# ACCESS PERMIT APPLICATION

Application Date: 09/18/2023 Physical Address of Property: 2260 Stage Road

Description of Project: Creation of a new residential driveway Is property in floodplain? No

## Re: 2260 Stage Road Driveway Access

**Driveway Plan and Profile**

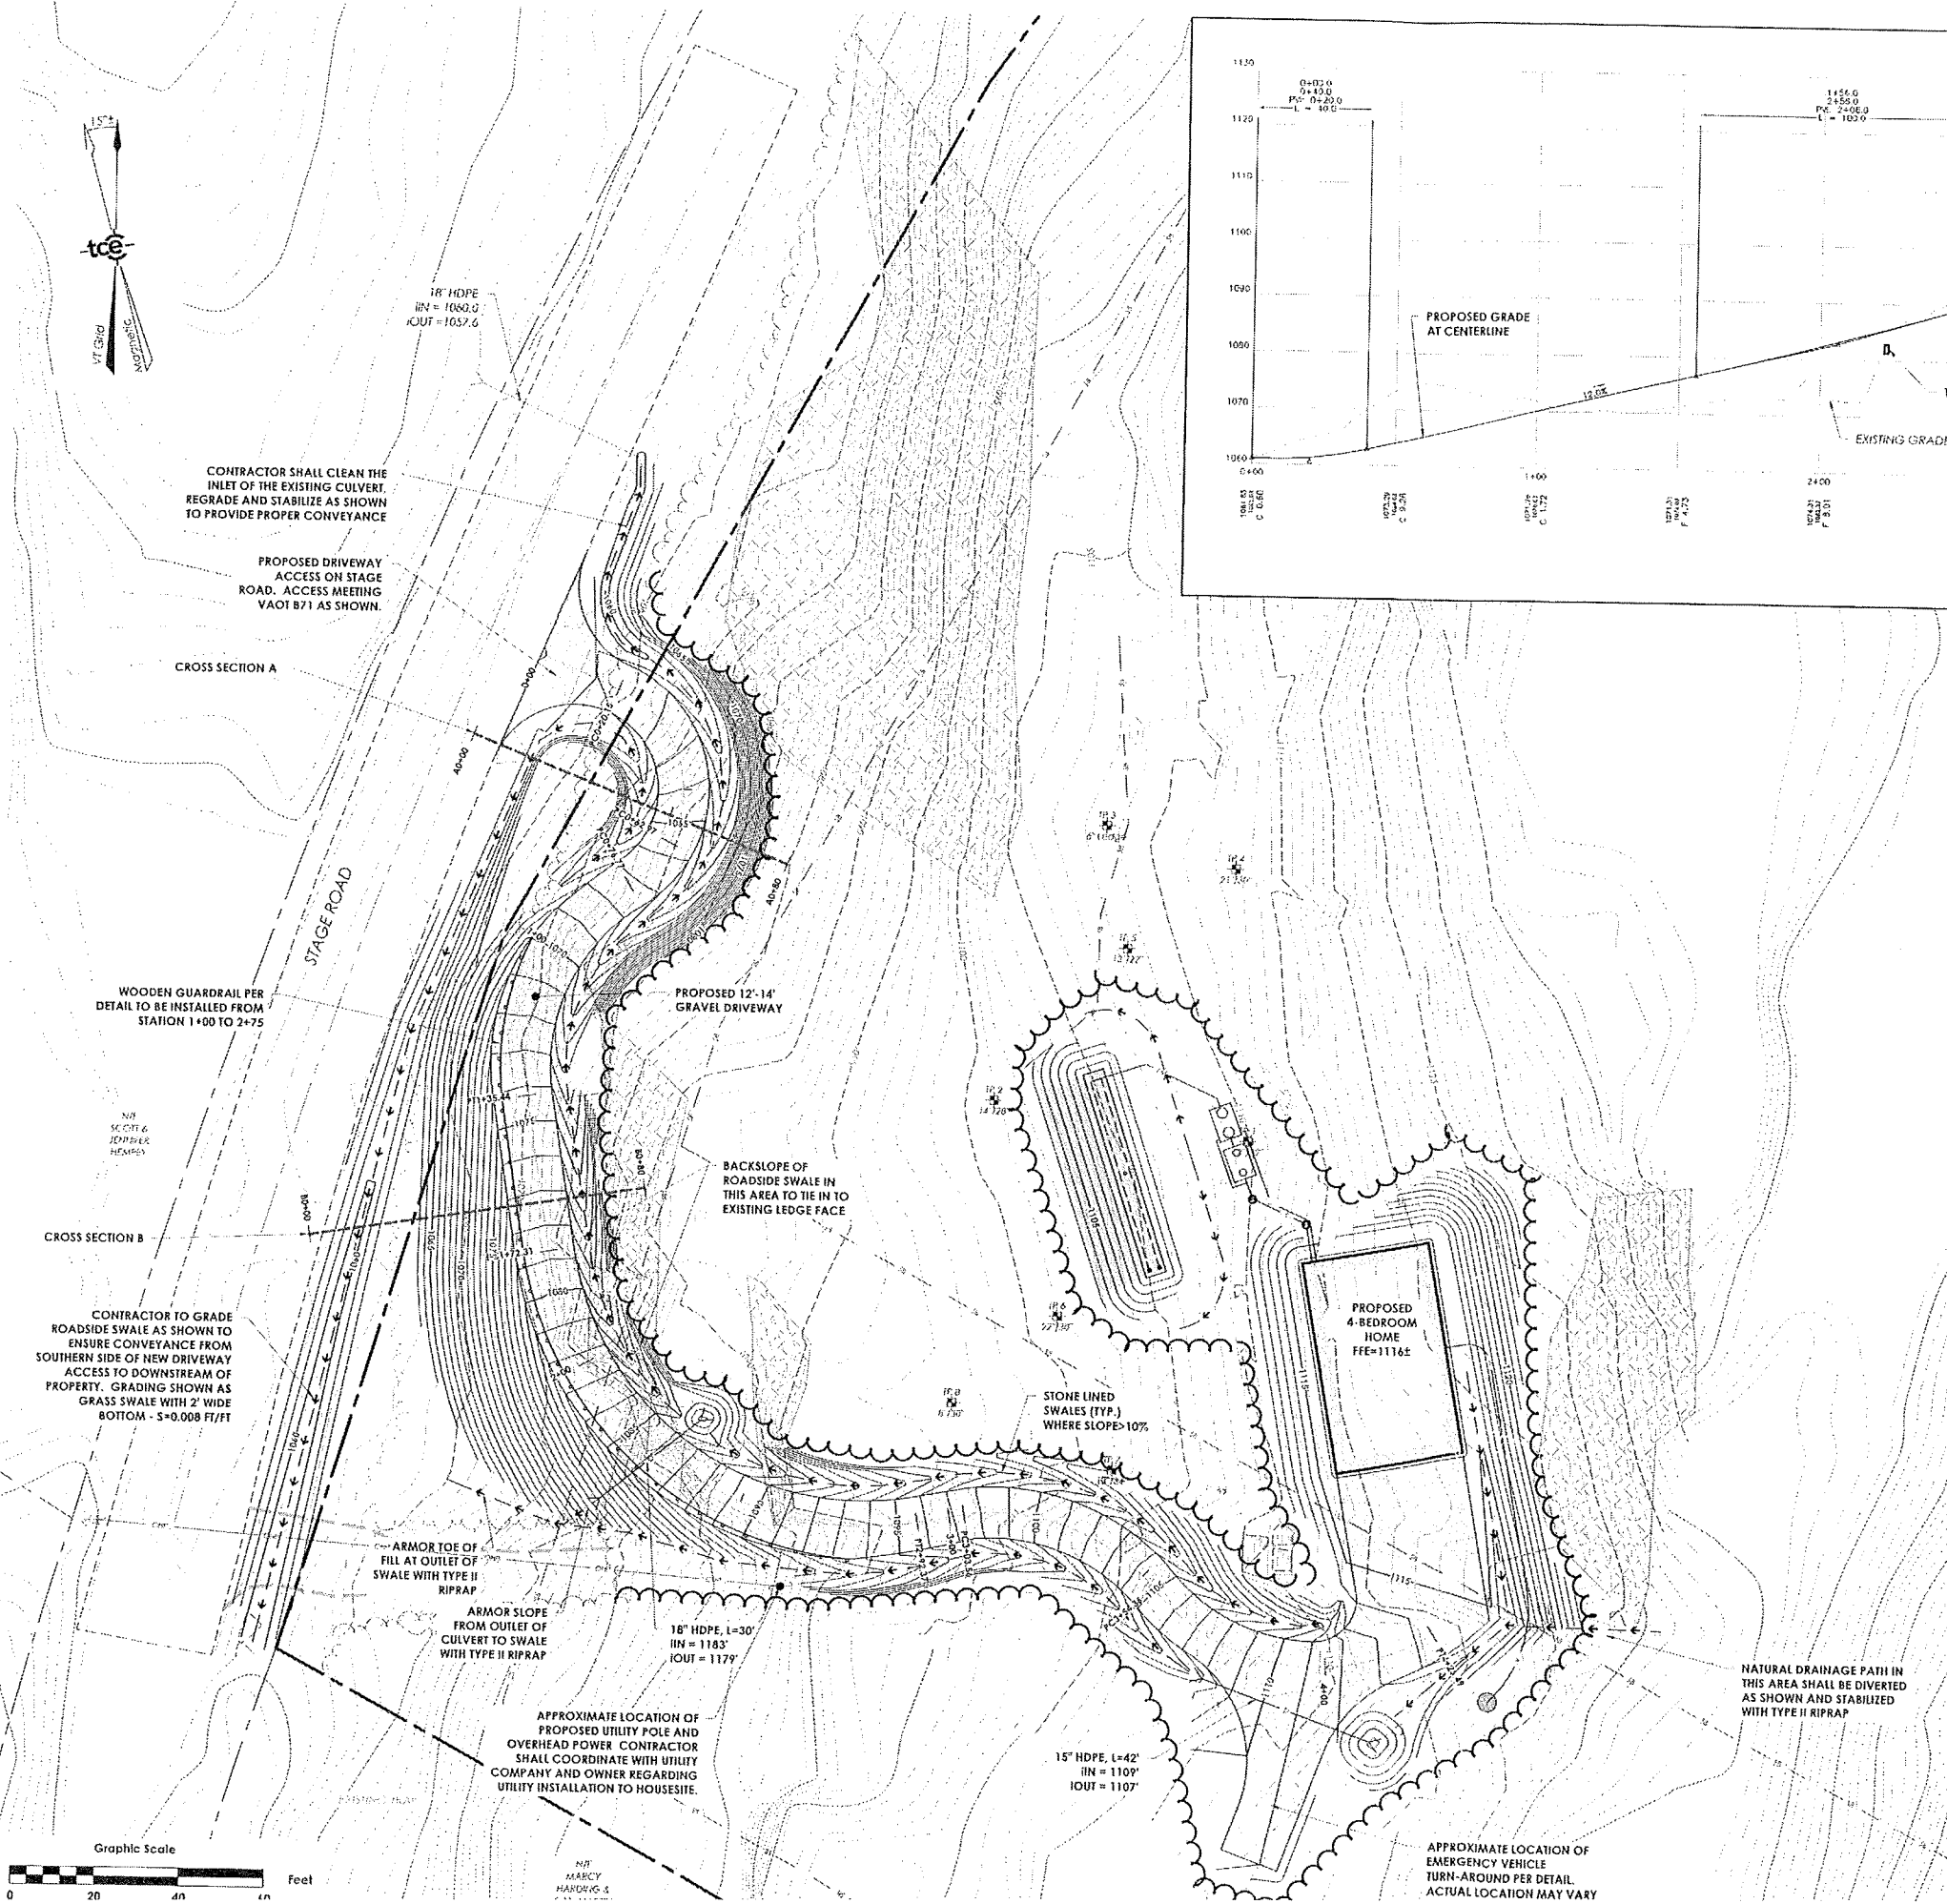
Comments: SIGHTLINE FROM ACCESS LOOKING NORTH AND Additional comments on reverse

Highway Department Comments: SOUTH EXCEED 390' AFTER TREE CLEANING ON SOUTH SIDE OF ACCESS IS COMPLETE. PR 15" x 30' HOPE CULVERT TO BE INSTALLED AND DITCHED TO →

CARRY DITCH WATER TO ROAD CROSSING CULVERT NORTH OF  
ACCESS.

Thanks for taking my call regarding the driveway for 2260 Stage Road. As discussed, the intent is to remove the existing trees between the driveway and roadway, south of the new access.

We also discussed requiring a culvert at the entrance and this will be added. As noted, it is flat so a 15" would be preferred if possible.
